Our ref: 10198

24 June 2021

Planning application for additional first floor extension to existing bungalow at 15A Salterns Lane, Hayling Island, PO11 9PH

Figure 1 – Comparison between outline of existing, refused and proposed

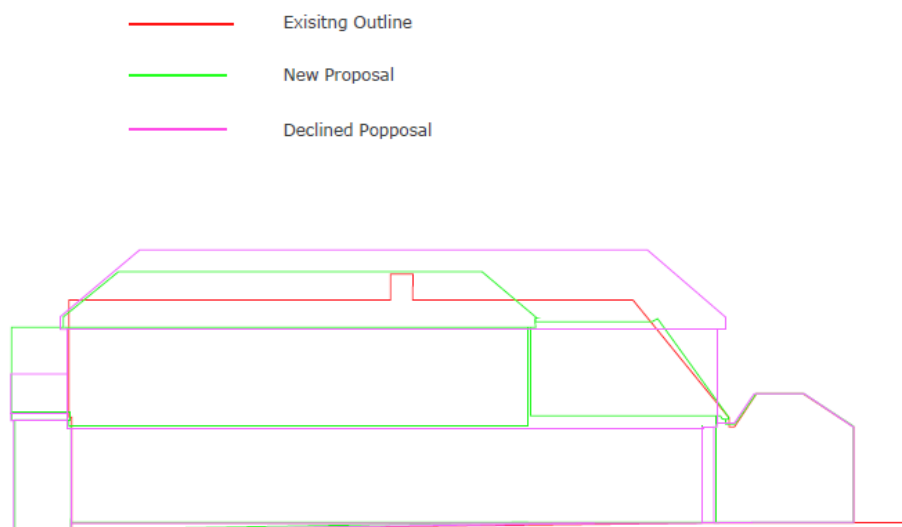
- The increase in the mass and bulk on the west and east facing elevations (to a depth of 16.5m) particularly in relation to 13A where it would run the length of the garden leading to a loss of sense of openness;
- Proposed eaves heights at 5.5m being nearly the same as the existing ridge height at 5.8m resulting in an overbearing development;
- Increase in glazing on the western elevation from the stairwell window and window to bedroom 3 meaning it could not be obscure glazed resulting in a loss of privacy from being overlooked;
- Concern about the proposed balcony that would result in overlooking of the northern end of the neighbouring gardens.

The proposal has been amended in the following ways:

- The ridge height has been reduced to be no greater than the height of the chimney on the existing dwelling – 6.65m;
- To reduce the scale and bulk of the proposed enlarged dwelling there is no longer a 16.6m expanse of first floor, there is a stepped change with the southern end of the dwelling being reduced in height from its existing height (as demonstrated by Figure 1) thereby reducing the mass and bulk of the southern end of the development this should ensure the retention of views from No.13A across the application site to the water (see artist impression on D14 and D15 of the planning package). In turn this will ensure the sense of openness for 13A is protected;
- Reduction in the eaves from 5.5m to 5.2m;
- First floor depth reduced from 16.6m to 12m;

- Bedroom 1 to remain as previously proposed with a high-level obscure glazed window on the western elevation and window on the eastern elevation with balcony to the north. The balcony is now a combination of glass and wooden finish to satisfy the AONB officer and to the east and western sides a brise soleil is proposed to reduce the overlooking concerns;

- Bathrooms and laundry room to remain with obscure glazed windows in eastern elevation;
- Bedroom 2 on the eastern elevation window is removed and replaced with a Velux window, on the western and southern elevations the windows are removed. Whilst not previously noted as an issue it further reduces overlooking to No.17 and it removes any overlooking to No.13A;

- Window to the stairwell is proposed to be obscure glazed now and has been reduced in size. Whilst not serving a habitable room there was a concern with this window previously. However, a window is required to provide some natural light to the stairwell and so an obscure window is now proposed.

- Bedroom 3 to have an obscure glazed window and a Velux window to prevent overlooking but to also ensure enough natural light for the bedroom.
